**GOVERNMENT OF THE DISTRICT OF COLUMBIA
DEPARTMENT OF TRANSPORTATION**

MEMORANDUM

SUBJECT: Zoning Commission Case No. 14-15 – 1244 South Capitol Residential

Figure 1 Site Access (Source: Applicant's CTR)

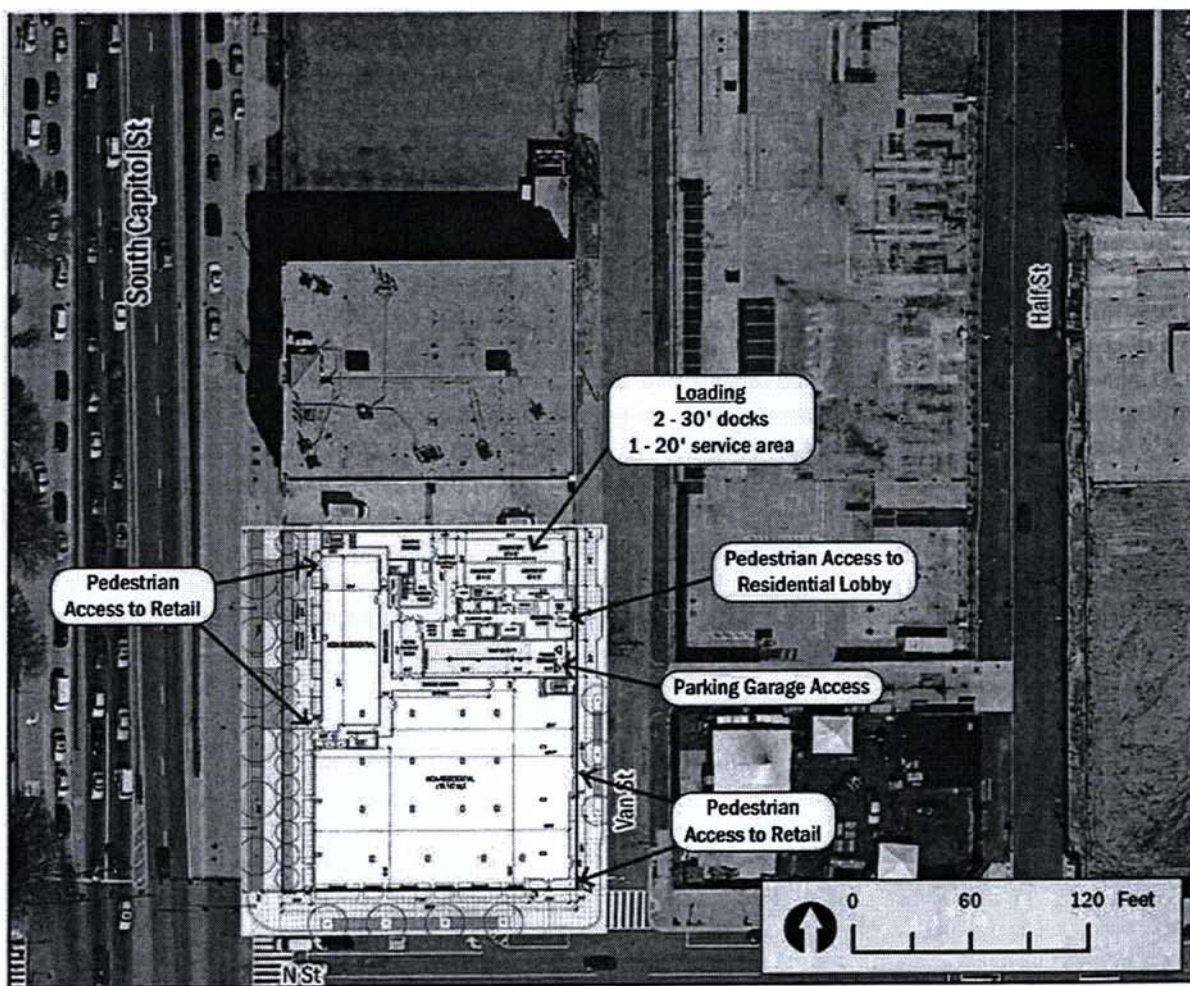
The development proposes two 30-foot loading docks and a 20-foot service area, in lieu of one 55-foot dock and a 20-foot service area. These loading berths are back-in/front-out, located on Van Street. The Applicant proposes the following loading management plan:

DDOT finds the loading management plan acceptable and expects the Applicant to fulfill its requirements.

- Detailed truck turning templates with lane markings and a curbside signing plan will be required during the public space permitting.
- DDOT recommends that the Applicant provide at least 1 parking space with a 240-volt electric car charging station located in the underground parking garage for use by its residents.
